Access Compliance Report

Public Rights-of-Way

Intersection ID: 28257	Main Street: OLYMPIC CLUB DR	Cross Street: PINE VALLEY CLUB DR	Location: NW
ADA ID: 800C21DD53EA	Ramp Type: PerpDiag	Initial Pass/Fail: Fail	Overall Compliance: No
		Severity Score: 25

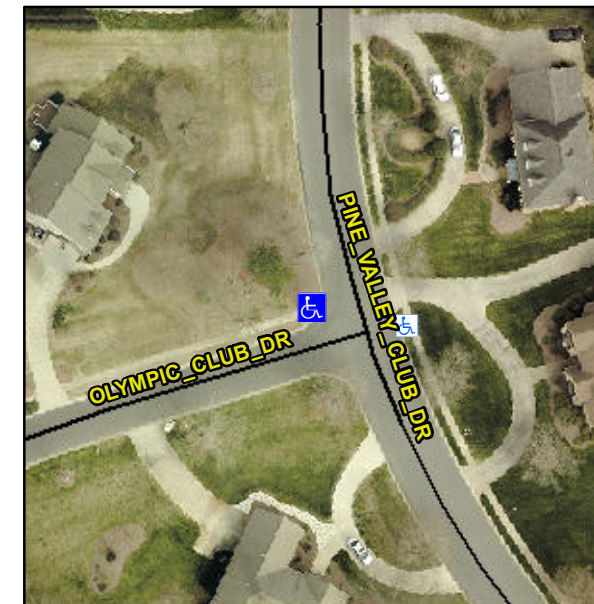
Not Found, R304.2.2, R304.5.3

Compliance	Description	Data	Compliance	Description	Data
N/A	Ramp Length (in)	48.0	No	Ramp Slope (%)	9.6
Yes	Ramp Width (in)	48.0	No	Ramp XSlope (%)	6.4
N/A	Flare Type LT	N/A	N/A	Flare Type RT	N/A
N/A	Flare Slope LT (%)	N/A	N/A	Flare Slope RT (%)	N/A
N/A	Flare Traversable LT?	N/A	N/A	Flare Traversable RT?	N/A
N/A	Landing Length (in)	N/A	N/A	DWS Provided?	N/A
N/A	Landing Width (in)	N/A	N/A	DWS Contrast?	N/A
N/A	Landing Slope (%)	N/A	N/A	DWS Length (in)	N/A
N/A	Landing X Slope (%)	N/A	N/A	DWS Full Width?	N/A
N/A	Landing Curb? (Y/N)	N/A	N/A	DWS Offset (in)	N/A
N/A	Shared Landing?	N/A			
N/A	Gutter Ponding?	N/A	N/A	Gutter Slope (%)	N/A
N/A	Gutter Lip Ht (in)	N/A	N/A	Gutter X Slope (%)	N/A
N/A	Painted X Walk1?	No	N/A	Painted X Walk2?	No
	X Walk 1 Direction	To S		X Walk 2 Direction	To SE
N/A	X Walk 1 Width (in)	N/A	N/A	X Walk 2 Width (in)	N/A
	X Walk 1 Slope (%)	1.0		X Walk 2 Slope (%)	6.8
	X Walk 1 X Slope (%)	3.4		X Walk 2 X Slope (%)	3.3

Remove & Replace Curb Ramp With Two New Directional Ramps or Equivalent.
